# United States Patent and Trademark Office

APPLICATION NO.	I	FILING DATE	FIRST NAMED INVENTOR	ATTORNEY DOCKET NO.	CONFIRMATION NO.
10/651,047	10/651,047 08/29/2003		Teruaki Itoh	160-389	8529
23117	7590	04/05/2005		EXAMINER	
		RHYE, PC	CHIN, PAUL T		
1100 N GL 8TH FLOO		AD	ART UNIT	PAPER NUMBER	
ARLINGTON, VA 22201-4714				3652	
				DATE MAILED: 04/05/2005

#### **DETAILED ACTION**

2,115,015

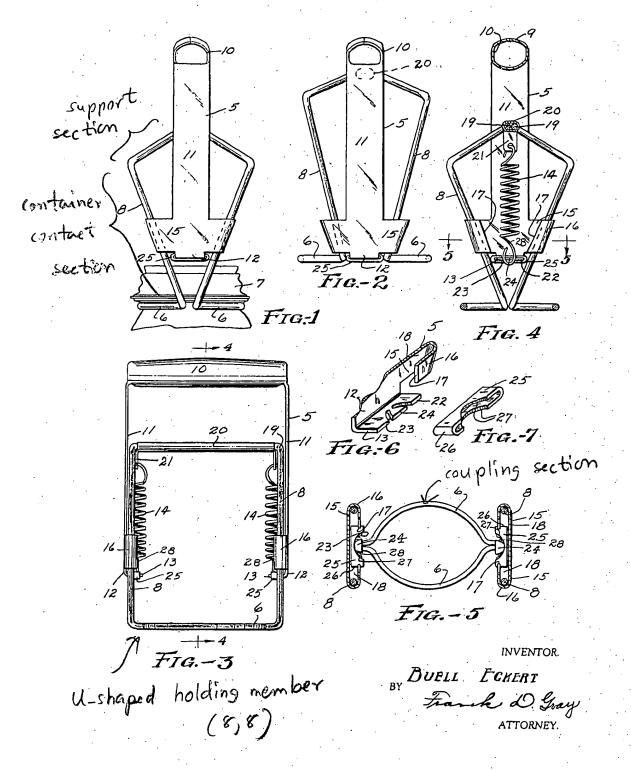
Eckert (2,115,015) discloses a container gripping device (see Exhibit A), comprising vertical and narrower strips (11,11) and spring coils (14), which can be considered as an open/close driver, a pair of opposed holding members (8,8) (Figs. 1,2, and 4) being formed of a substantially bent member portion and a substantially linear member portion, the member being made of strong wire (lines 28-31 of page 1), which is a metal wire, each holding member having (i) a pair of support sections (upper section of member 8), one end being coupled to the driver (see Fig. 4), (ii) a pair of container contact sections (lower portion of the holding member 8) which are connected at one end to the support sections, extending along a lengthwise direction of the container and biased toward the container, and (iii) a coupling section (6,6) (Fig. 5) or strong wires which couples other ends of the container contact sections and are curved so as to surround the outer surface of the container with a gap there between (see Fig. 1).

Re claim 10, a u-shape holding member (8,8) is clearly shown in figure 3.
